PERCOLATION TESTING

PERC TEST AS-BUILTS

HUDSON PROPERTY

Hudson Property Lots 1-4
Frederick Road

(A) SOIL PROFILE

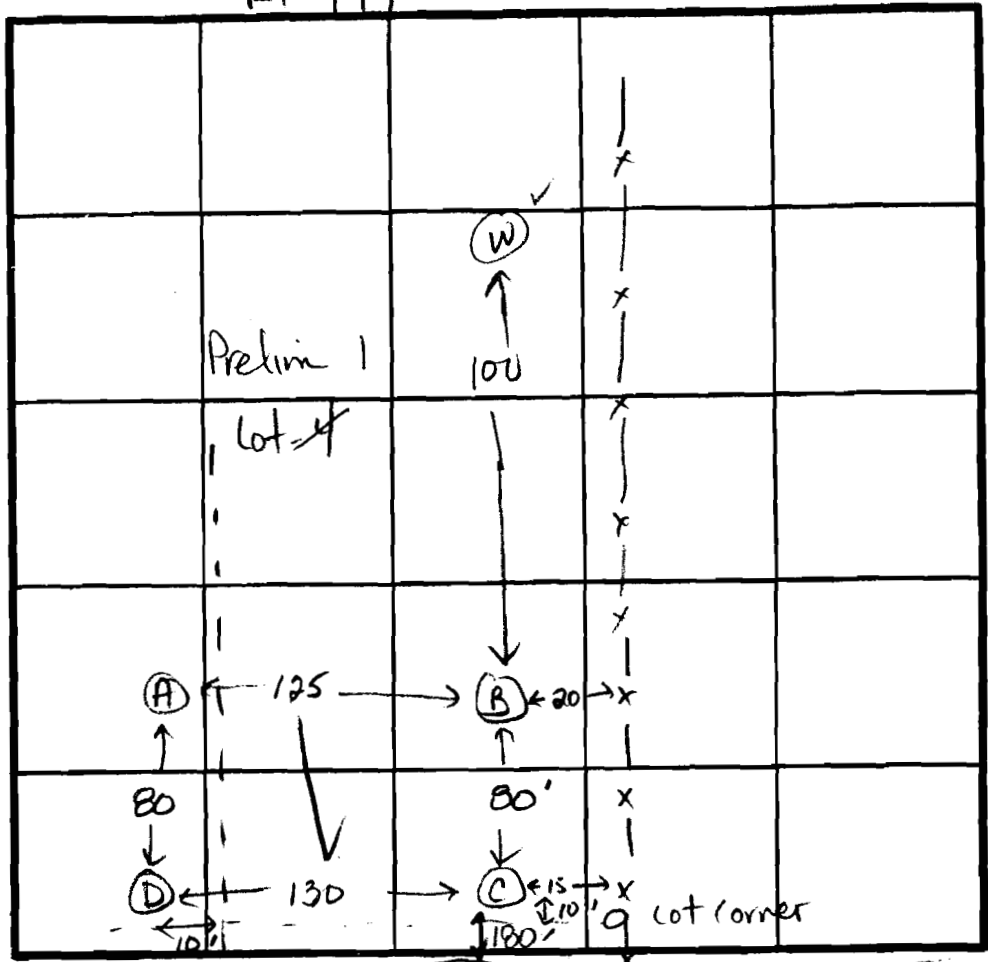
REASONS FOR REJECTION OR HOLDING 5-9-89 pending perc hole locations
and subdivision plat approval (EN)

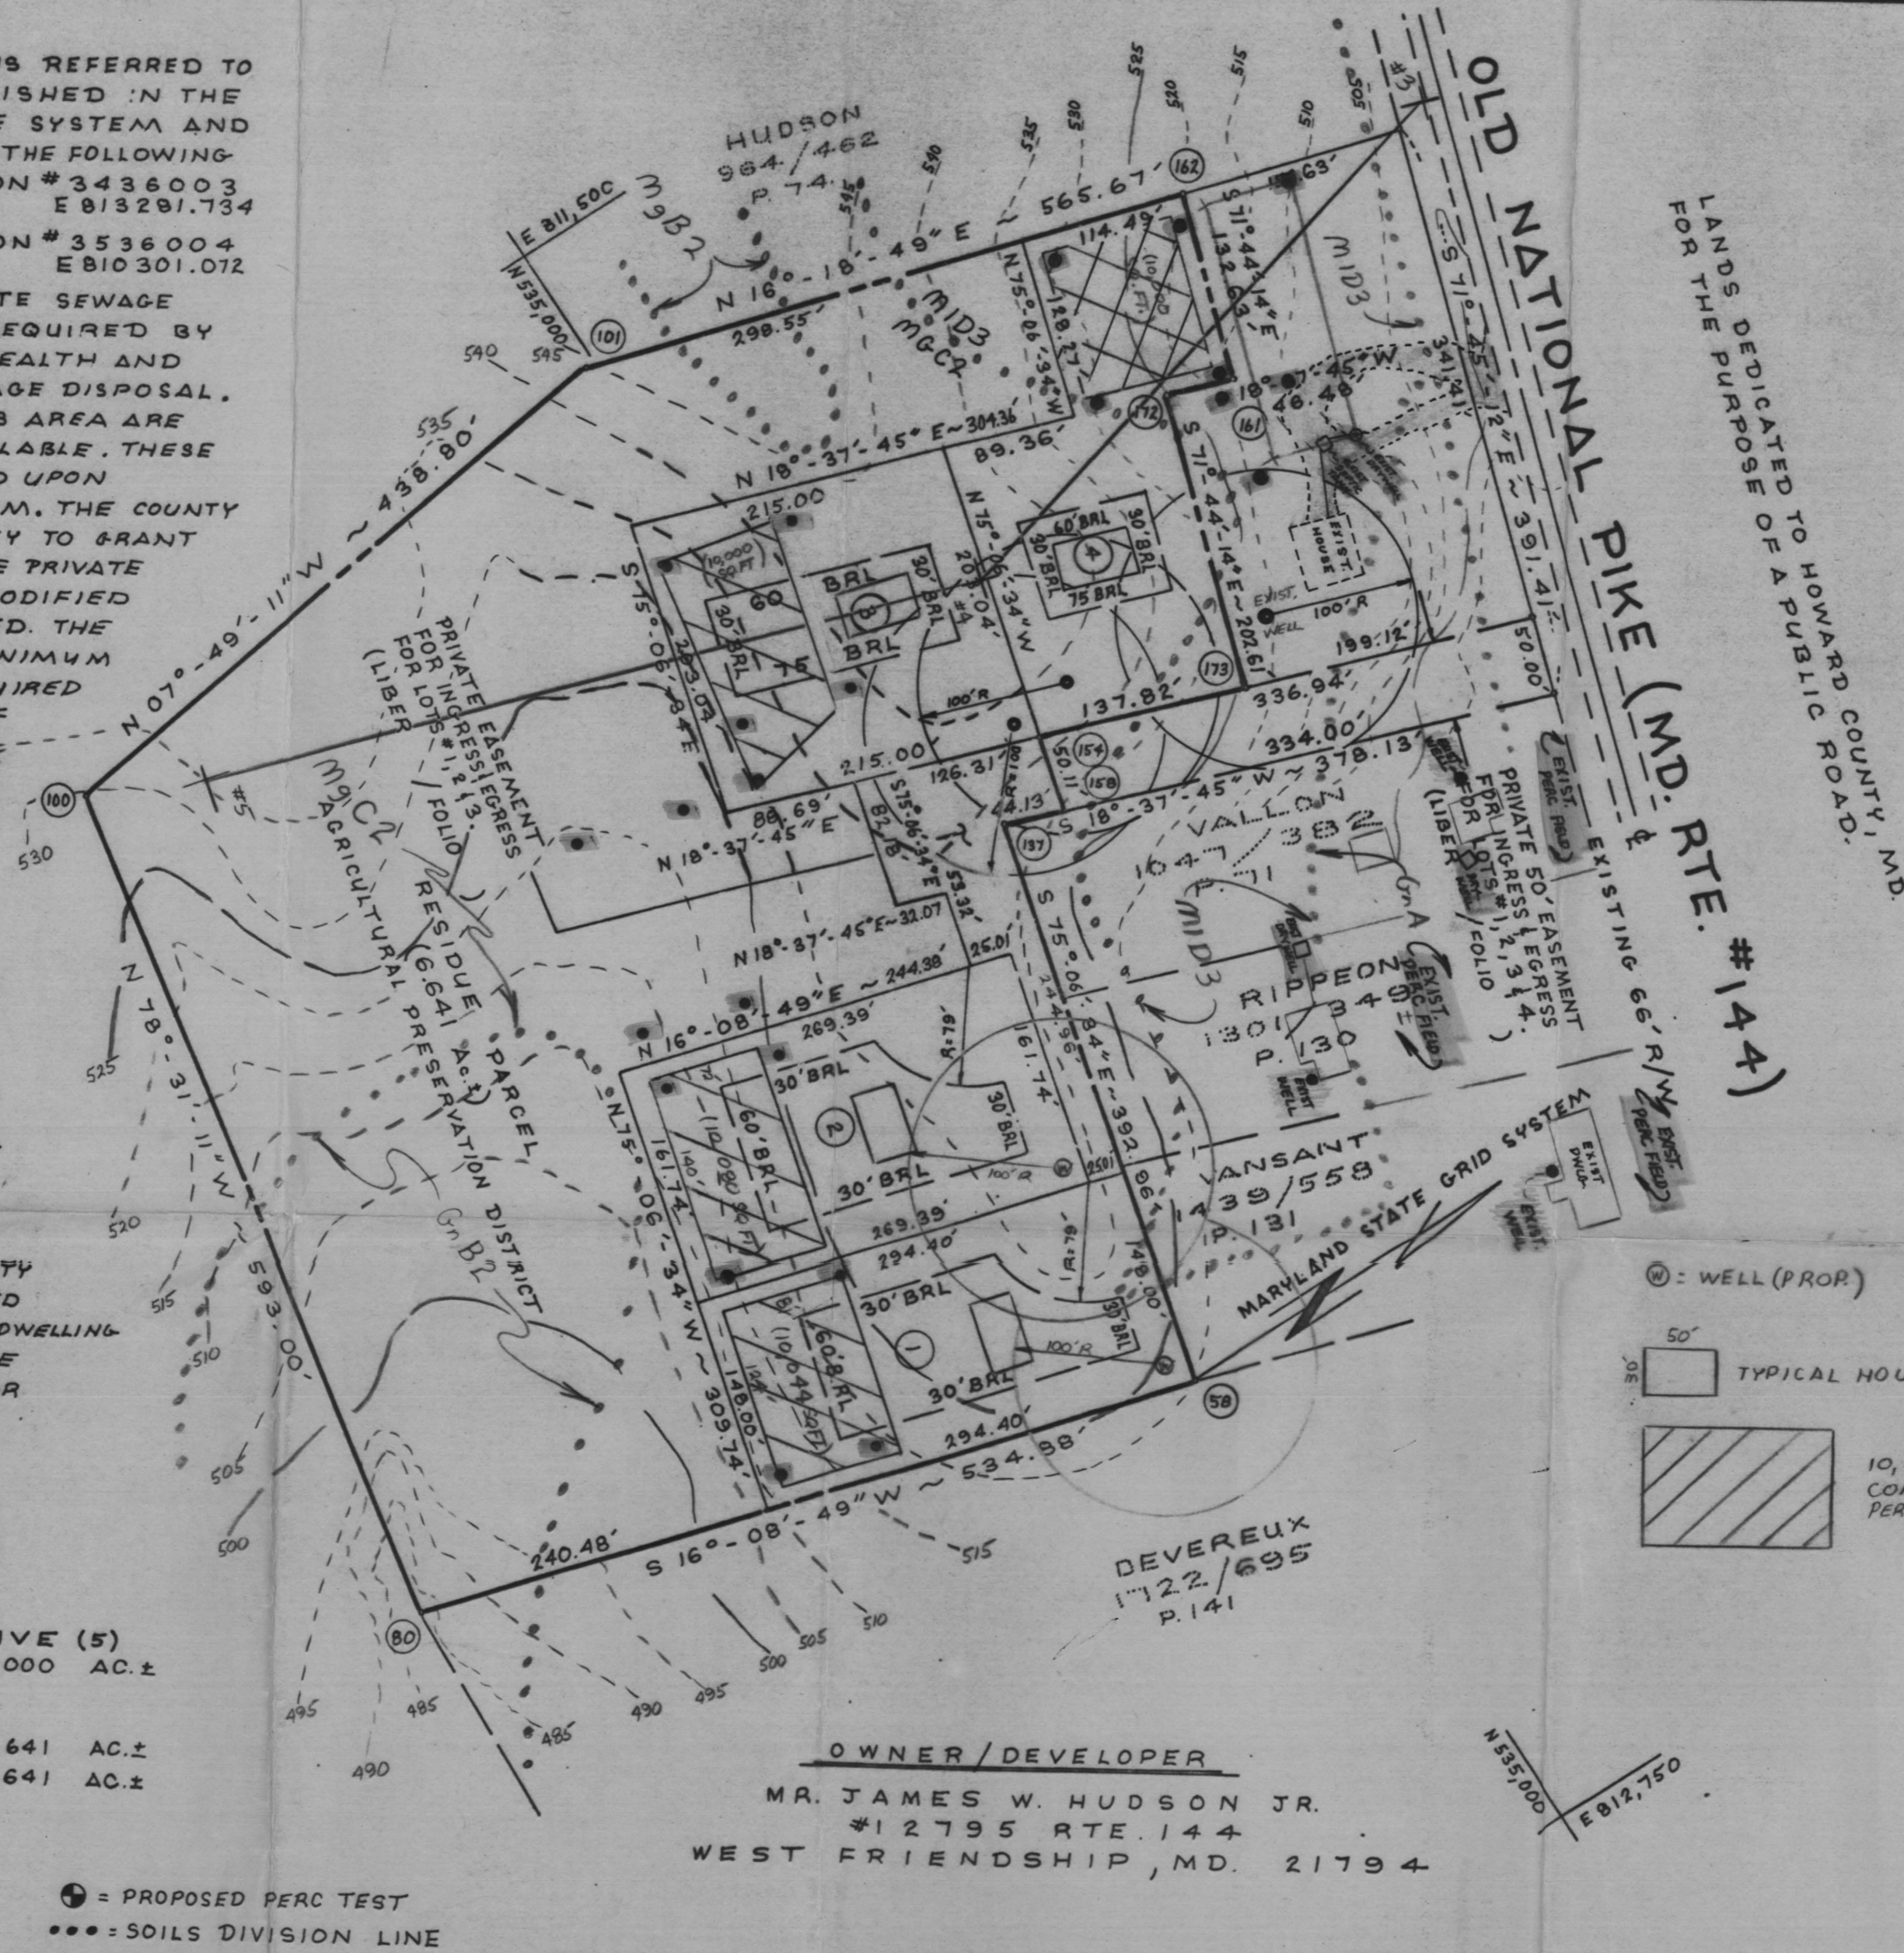
Must show all existing septic
easement and well locations
on adjacent properties

A 43980 New Lot-1 Old Lot-4

Septic easement ok

— Need well and house site.

— Need elevations of perc holes

A 43979 New Lot-2 Old Lot-3

— Septic easement less than 10,000 sq. ft.

— Need well and house site.

— Need elevations of perc holes.

A 43978 Not used Old Lot-2 Failed

A 43977 New Lot-3 Old Lot-1

Septic easement ok

— Need house location.

— Well must be higher than septic
easement. (stay 100 ft from cow pasture)
minimum

— Need elevations of perc holes.

New Lot-4

No perc testing done to date

Proposed septic easement is probably
in Existing House lot septic
repair area,

— Hole #A appears higher in elevation
than field notes.

~~Must show repair area and
existing system (septic tank and
drywell)~~

~~Should indicate failed perc
holes with different pattern
than passed perc holes.~~
